Re: Ncwt Requests

Hello all, it has been many months since the replacement of the road base was agreed upon (for the areas where erosion is evident). Can we please get this done so this project can finally be out of the way? See the attached schedule. I didn't think I would need to extend this to 2019, but if this goes into 2020, it will be almost 10 years since the project started May 2010.

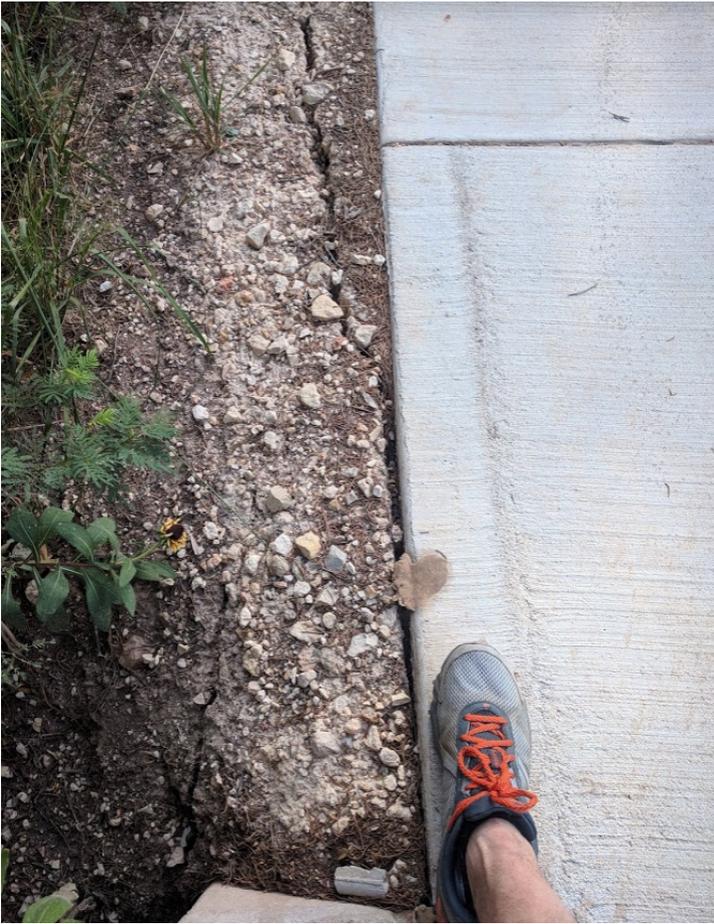
1) the cracked pavement near STA 21+00, noted last spring is shifting with the dry weather and now has about 1" vertical gap. Here is a picture from April 9, 2019. I didn't take one today.
